## Staff Report

To: BOZAR  
From: Jessie Earley, Town Planner III  
Meeting Date: DRC, February 1, 2025  
RE: Liebl (226 Sopris Avenue), Secondary Review

**PROJECT TITLE:** Liebl (226 Sopris Avenue)

*1/21 DRC: Proposed Site Plan*

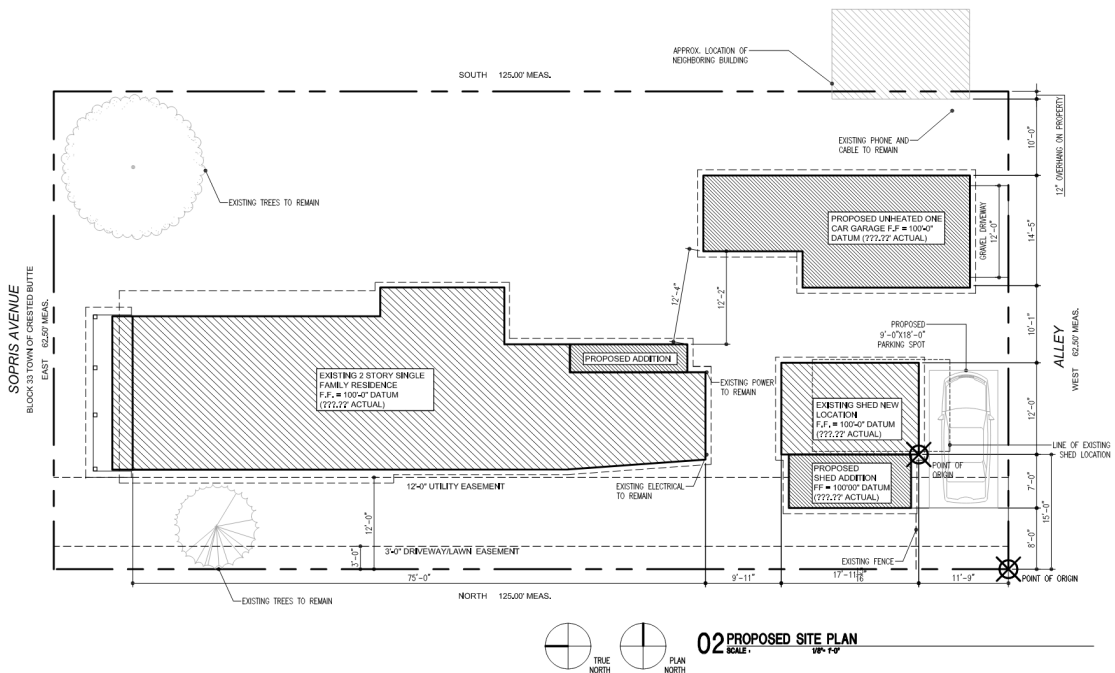
GL	Staff Analysis	DRC Recommendation
Topography	Topography is not included, but should be. This information is not anticipated to impact FAR or height requirement.	Add information to the plans
2.8 Drainage	<b>Drainage arrows have been shown and show drainage to the north and south to the alley.</b>	Add information to the plans, which has been provided.

Easements	There area existing easements on the west portion of the lot, which includes a 3' driveway easement and 12' utility easement. There is a letter from the property owner to the east expressing support for the addition.	Support with neighbor support.

2.16 Substantial landscaping	The plan is fairly minimal. Provision of a final landscape plan will be required if there are revisions after permitting.

2.18/3.1 Preservation of existing mature trees	There are existing trees on the north portion of the lot, which are to remain and will not be impacted by the additions. <b>The applicant has added the existing trees to the lot and no trees will be removed.</b>	Confirm number of trees, which has been provided.

2.19 New trees	There are no new trees noted on the plans.	
2.16 a./ 2.20 Native plantings	<b>Ground cover for disturbed areas has been noted as grass.</b> Native plantings are encouraged by the GL.	Add information to plans, which has been provided.

2.16 e Pervious materials	<b>The existing flagstone patios and walkways are to remain.</b>  <b>Parking has been included on the proposed site plan as gravel.</b>	Add information to plans, which has been provided.

2.28 e & f Parking substrate	<b>Parking spaces are noted on the site plan. Substrate is called out as gravel.</b>	Add information to plans, which has been provided.

(2.37-2.40)/ 16-17-40 Exterior Lighting	<b>Existing and proposed lighting has been included. They appear to meet the intents of the requirements.</b>  If existing fixtures do not meet requirements, they will be required to be upgraded as part of the work to be done.	Add information to plans, which has been provided.
Solar	NA	NA
Utilities	Existing and proposed wet and dry utilities must be noted on the plan.  Rights of way (alley and Sopris Avenue) must be shown to scale on the site plans.	Add information to the plans.

2.7 Snow Storage	Snow storage has been depicted on the plan and corresponds to the areas to be plowed.	Support
2.27 Fences	An existing fence is on the south. Confirmation is needed if there will be a new fence proposed.

**02 SOUTH ELEVATION - EXISTING**  
SCALE: 1/8"=1'-0"

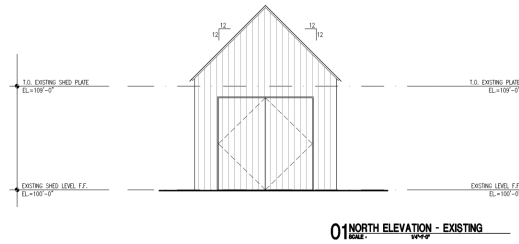
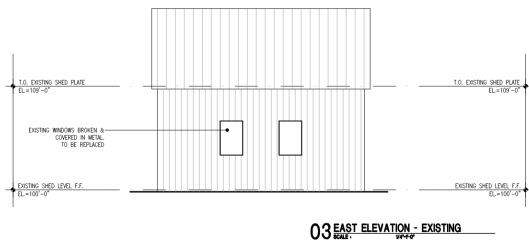
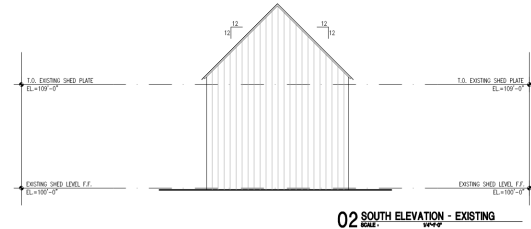
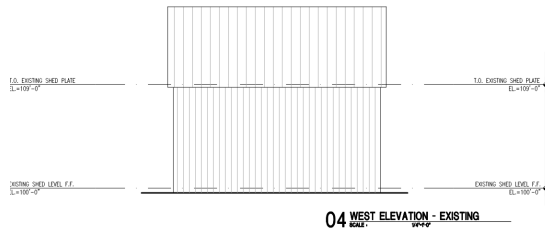
GL	Staff Analysis	DRC Recommendation
3.17 Additions to historic buildings	<p><b>Primary:</b> The addition to the primary building fills in a small area on the southeast corner. A 3D rendering showing the existing and proposed area would be helpful to show the change. <b>The proposed renderings have been provided.</b></p> <p><b>Accessory:</b> The addition to the accessory building steps down from the main ridge and also from the north and south. A change in material would be encouraged.</p>	Support

3.18 a Stepping down additions	<p><b>Primary:</b> The addition will continue the roof pitch that is existing in the southwest corner of the building 12:12.</p> <p><b>Accessory:</b> The addition on the west steps down 4'3" from the main ridge. Discussion is encouraged to determine if the addition is subordinate.</p>	Support

3.18 c Mass	<p><b>Primary:</b> The size of the addition (110 sf) is much smaller than the size of the original structure (2273 sf) per GL 3.18 c. The mass of the addition will be placed on the rear, but as noted a 3D model of the addition would be of help.</p> <p><b>Accessory:</b> The existing AB is 216 sf and the addition is 111 sf, which is smaller in size.</p> <p>Staff feels that neither addition appears large in comparison with the existing structure and other structures in the surrounding RIC zone district and the proposed plans match scale of the surrounding buildings within the zone.</p>	Support

3.19/ 3.37 Additions as products of their own time	<b>Primary:</b> The addition is proposed to match the existing primary building, which is appropriate given the size.	Support

**02 SOUTH ELEVATION - PROPOSED**  
SCALE: 1/4"=1'-0"

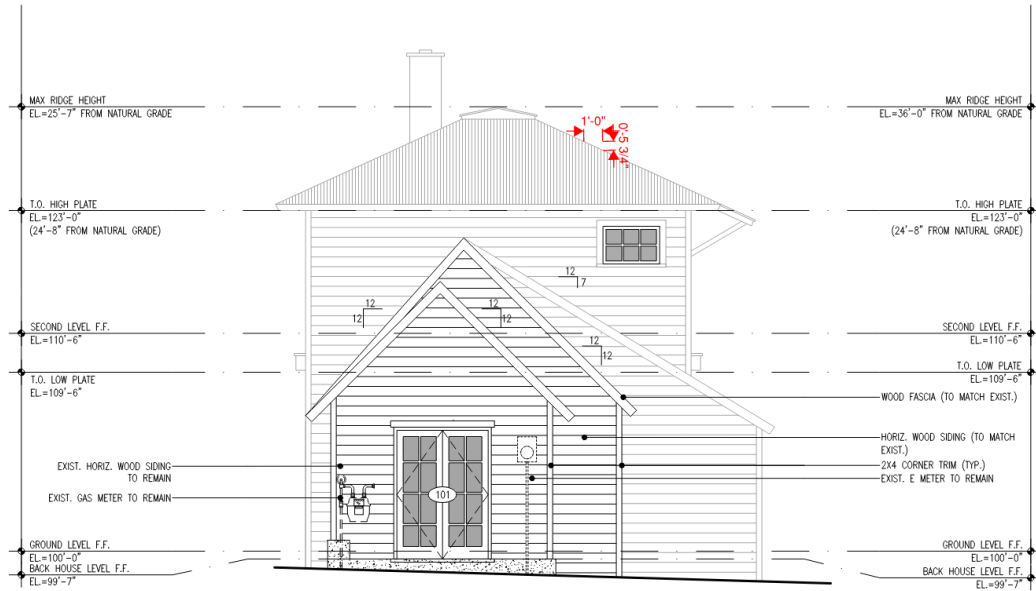
There is a new wood French door with divided lights proposed on the south. The door plan states that this door will be a metal clad door. Confirmation of the door materials is needed.

**01 NORTH ELEVATION - PROPOSED**  
SCALE: 1/4"=1'-0"

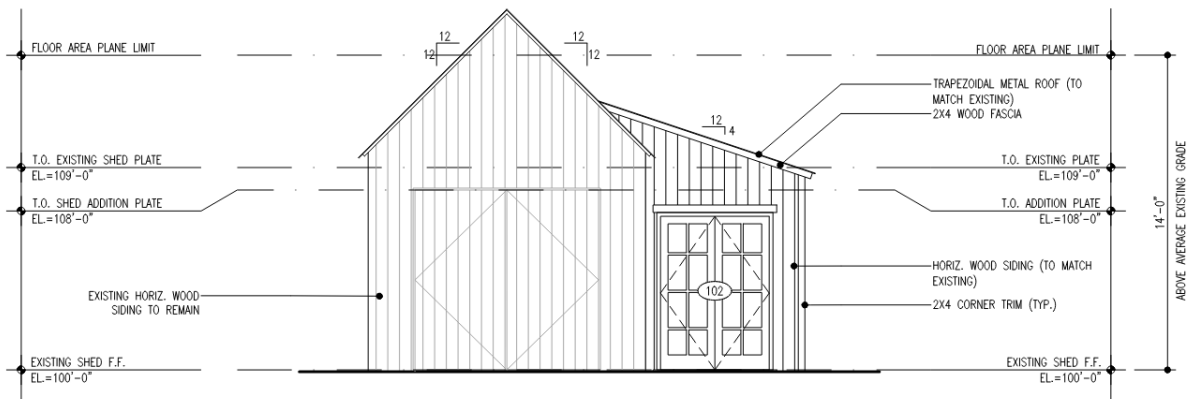
The garage door (carriage style) existing will be rehabilitated (north). There is a wood French door proposed on the north elevation with divided lights. The door plan states that this door will be metal clad, confirmation of the materials is needed.

1/21 DRC: flat plan views

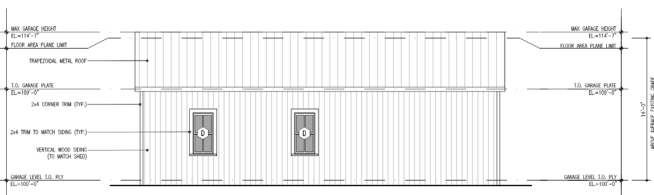
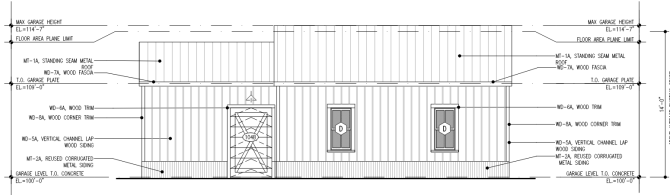
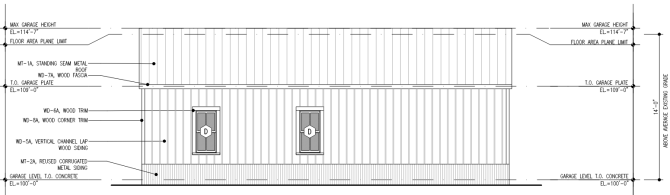
The proposed south cold accessory building is an 22’5”x15’2” gabled building with a smaller gable module to the north 13’x10’5”. The accessory has a 8:12 pitch. This must be a cold building due to the size, as proposed.

GL	Staff Analysis	DRC Recommendation
4.84 Smaller in size	The proposed building is smaller in scale than the primary building, as requested by the GL.	Support
4.85/5.94 Rear of the site	The proposed building is located at the rear (south) of the lot. Support.	Support
4.86 Vary appearance	As seen in the 3D models, this building is proposed to mimic the existing historic building to the west. The form of the building is simple and supported. However, the material should be varied from the building to the west.	Support  1/21 DRC: Members voiced that a small distinction would be good, but it should not be too different, as the nature of the buildings are simplicity. A slight differentiation has been provided.
4.89 d. porches	NA	NA

GL	Staff Analysis	DRC Recommendation
4.53; 4.89 AB fenestration	<p>There are two single windows on the north, east and west elevations. The south elevation has one window.</p> <p>There are fewer windows than the primary building. The window to wall ratio for the proposed north elevation is 17.6%. This percentage is more relational to primary building. Staff would suggest reduction in the glazing for this elevation.</p>	Support

GL	Staff Analysis	DRC Recommendation
4.66 Secondary Doors	There is a ½ light aluminum clad person door on the north, color must be confirmed. Support	Support
4.69, 4.90 Garage doors	There is a garage door proposed on the south elevation and a smaller garage door proposed on the west elevation. Wood veneer was referenced at the DRC meeting. There were traditional barn door details added to both doors.	Support

**Relocation plan:**

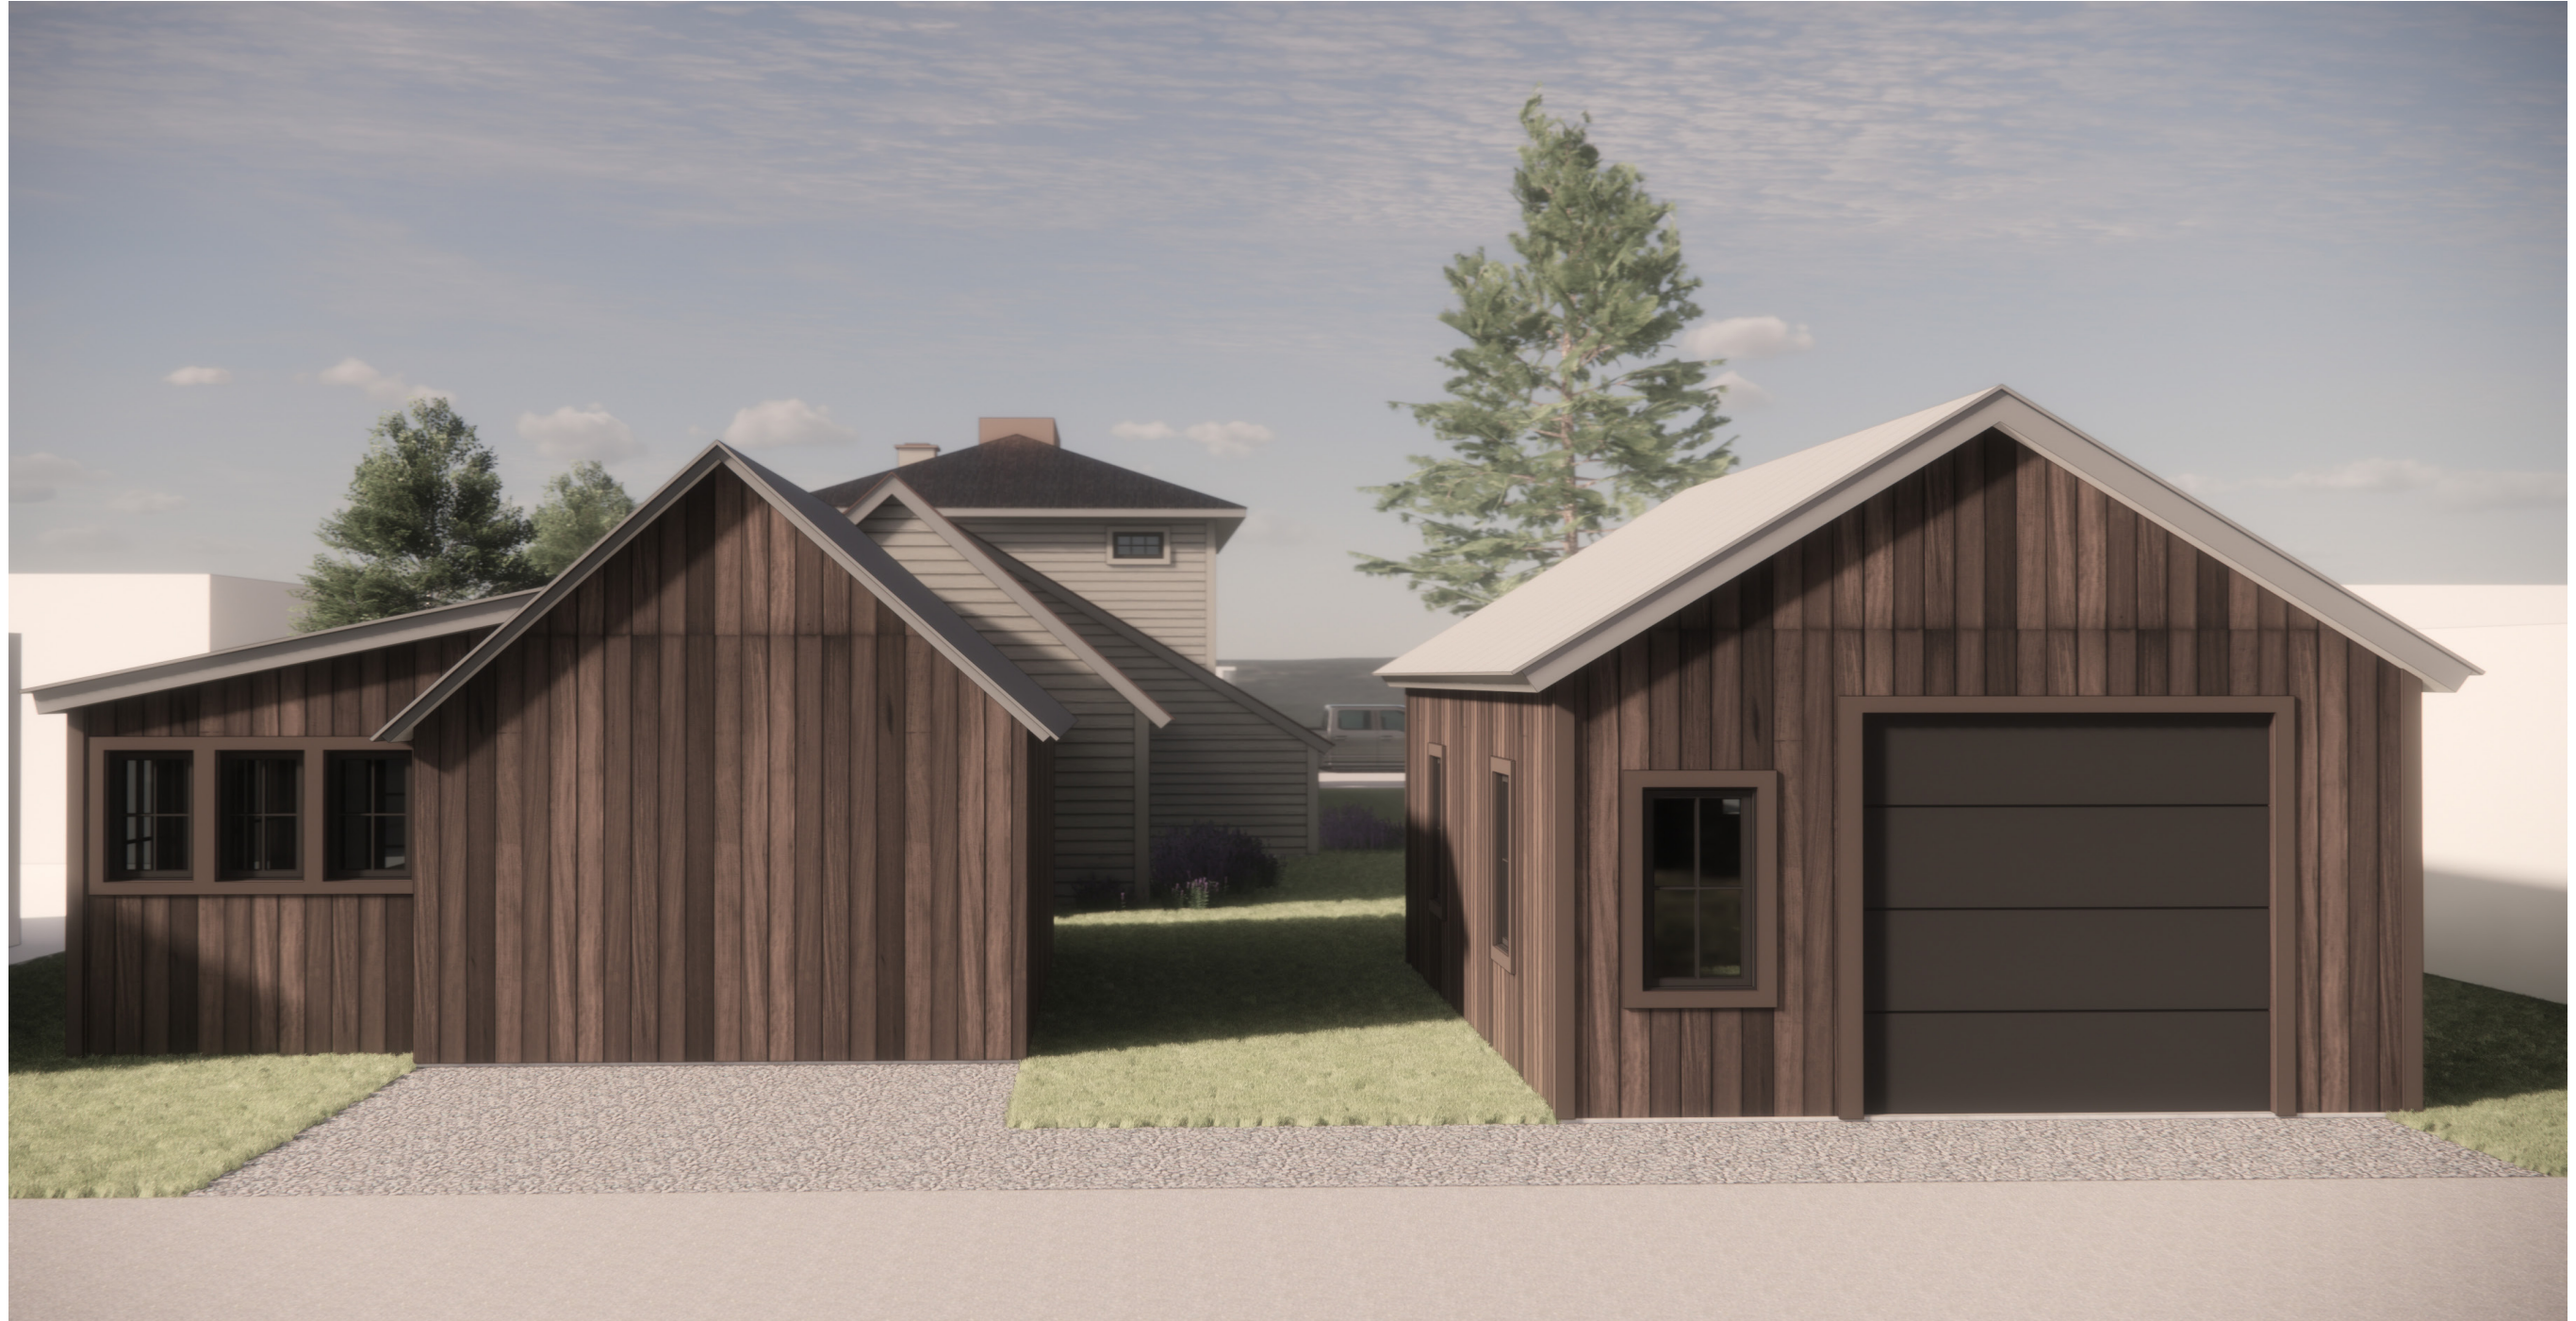
- The accessory building will be lifted and shifted 15' to the east temporarily.
- Then, a new foundation will be installed 5' to the north of existing accessory location.
- Shift the building to the new foundation with a small addition to the west.
- All existing framing will remain in place and new framing will be added from the interior.
- Vertical board on board siding to remain.
- Existing two windows are proposed for replacement.
- Existing exposed rafter tails to remain.
- Existing corrugated metal roofing to be replaced with rusted standing seam roofing.
- Existing trim details to remain.
- Existing barn style doors on north to remain and be rehabilitated.

GL	Staff Analysis	DRC Recommendation
3.2 Original footprint	The accessory building does not currently have a foundation and must be sited on a foundation. The property owners would like to shift the building 5' back to accommodate a parking space. Support.  The primary building is to remain. Support.	Support
3.8 Historic materials	The applicants propose removal of the windows, as described above. All historic windows must remain and be rehabilitated.
